XAUI Amplitudes Clause 47 results

Velio Communications

Comments to Clause 47

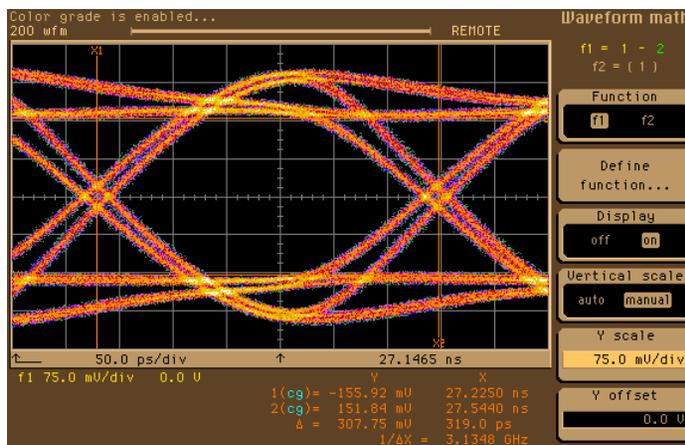
- Demonstration of nominal 50cm FR4 channel with 200mV at Rx. 2^{10} -1 PRBS.
- One channel measured; 8 channels switching uncorrelated PRBS at same frequency

Extend objective in some manner

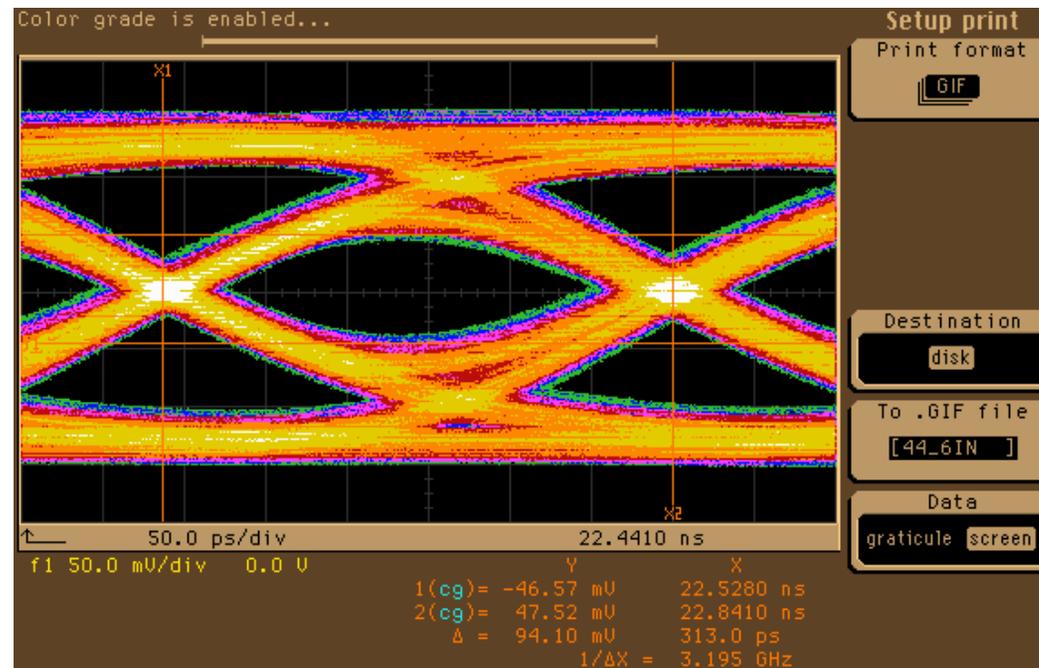
- Should we codify the 100cm / 2 connector application now or in the future?
- 44" FR4 / 2 VHDM-HD

- Create two numbers for the receive end:
 - 200 mV for backward compatibility
 - 100 mV for forward looking, low power applications
